CASE: PAR230075
EXHIBIT: Site Plan
DATE: 12-7-2023
PLANNER: E.Langan

NORTH SEATON INDUSTRIAL

COUNTY OF RIVERSIDE, CA
SCHEMATIC SITE PLAN

A1-1-P

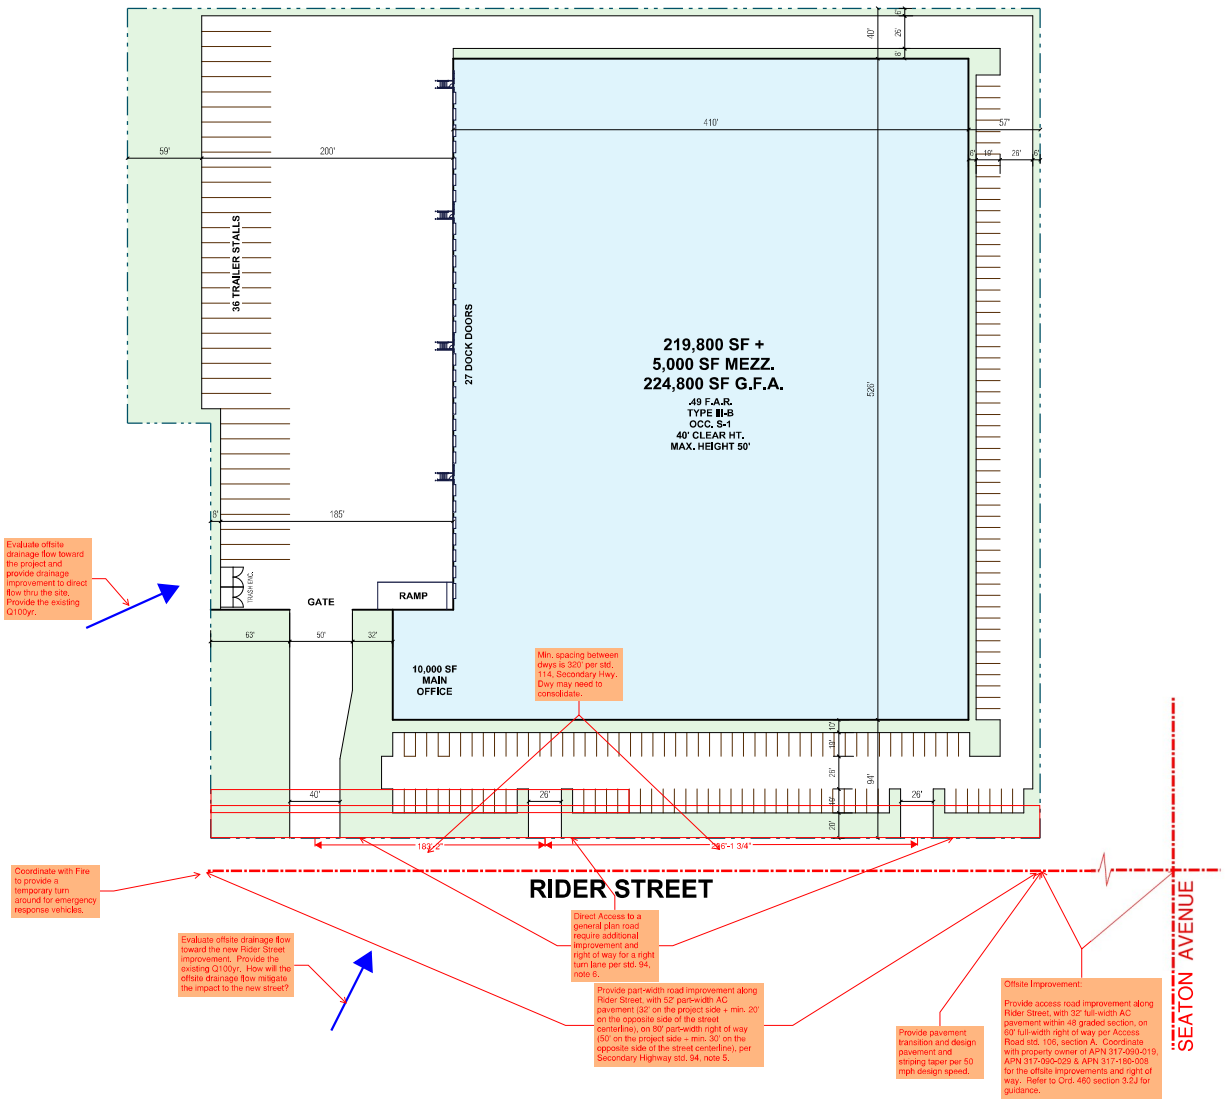
Provide a Preliminary WQMP. The WQMP shall include mitigation for any off-site street improvements.

Grading Comments:
1)Provide a conceptual grading and drainage plan.
2)Provide existing topography.
3)Include pad and finish floor elevations.
4)All manufactured slopes shall be shown as YYYY with the top of Y indicating top of slope and single leg of Y as toe of slope.

5)Provide Spot Elevations (proposed finish surface elevations) sufficient to demonstrate the streets, driveways, and drainage grades meet minimum requirements. Spot elevations should be provided at street intersections, cul-de-sac ends, beginning and end of driveways and all grade breaks.

6)Indicate whether the parking lots are asphalt or concrete. Keep in mind minimum surface grades are .35% for concrete and 1% for all other surface types.

7)If proposing walls: Identify wall types (garden or retaining). Provide typical sections with maximum retaining wall heights and total wall heights – includes any wall or fencing atop the retaining wall.

8)If a Water Quality Management Plan (WQMP) is required, please show location of all water quality BMPs and point of discharge per WQMP.

Provide a TIA and VMT for the project

Provide truck turning template for the onsite circulation and enter/exit onto Rider St; and also truck turning movements thru the intersection of Rider St and Seaton Ave.

Provide a conceptual grading exhibit

Provide a preliminary drainage exhibit

Show and label existing power pole. Power pole with lines sizes 33.6 kV or less, shall be underground.

Evaluate existing access for adjacent parcels. The Project to verify existing and ensure that the project improvement does not block existing access to the neighbor. Project may need to provide access improvement to the neighboring parcels if its land-locked.

Coordinate with Planning for trail requirements.

This project is located in a very High Fire Hazard Severity Zone. Clarify primary and secondary access in the east and west direction on Rider Street.

Provide a Fire Access exhibit and indicate the proposed fire hydrant locations.
